RE: **TownePlace Suites by Marriott at Baton Rouge Denham Springs, LA**
90% Design Review
*Review Outcome: **Revise as noted and resubmit with owner response before proceeding to Construction Phase***
[MI Review 11.20.17](#) : Marriott International Review comments. Note that Owners responses are acknowledged unless otherwise noted.

Review Comments - Site Plan and Building Exterior

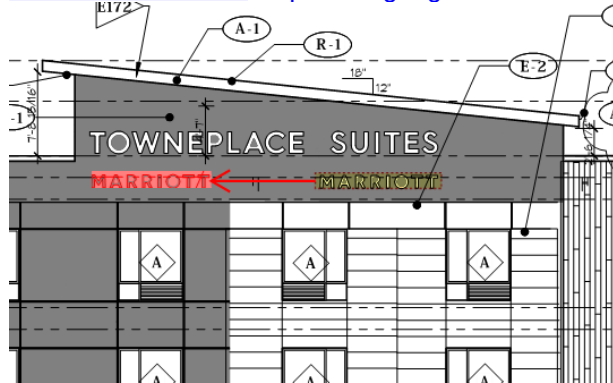
6. Submit samples of custom material and custom colors. Note that Fiber cement panel is custom.

Match panel sizes, colors and textures with the Nichiha.

MI Review 11.20.17 : Fiber cement is custom. Please submit samples. Avoid residential look by avoiding overlap of joints. The panels have to be laid flat.

Response: Not needed due to going with your prototypes.

RESPONSE: Samples will be provided by contractor.

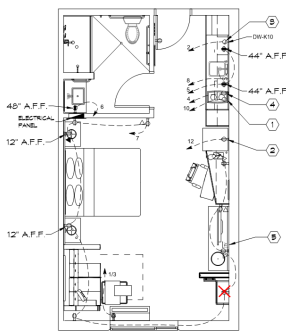
11. Remove all outlets from inside the closet.

MI Review 11.20.17 : Update E109 Acc King still shows outlet in closet.

Response: There are no longer outlets in the closet.

RESPONSE: Removed outlet.

10 DOUBLE QUEEN SUITE (POWER)
SCALE: 1/8"=1'-0"

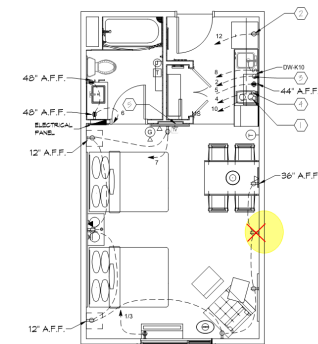
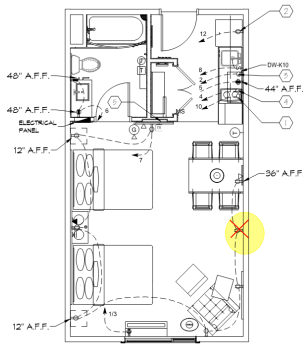
MI Review 11.20.17 : In QQ standard room types, eliminate unused outlets shown in E110, typical.

RESPONES: Removed unused outlets.

3 ACCESSIBLE DOUBLE QUEEN SUITE (POWER)
SCALE: 1/8"=1'-0"

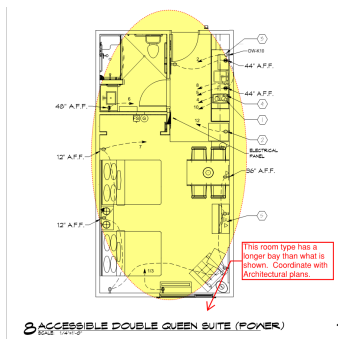
MI Review 11.20.17 : Acc. QQ room type shown in E110 bay depth does not match with floor plans. Coordinate Electrical with Architectural plans. Ensure Dining chairs have sufficient space to move and space requirements meet ADA standards.

RESPONSE: Fixed the depth.
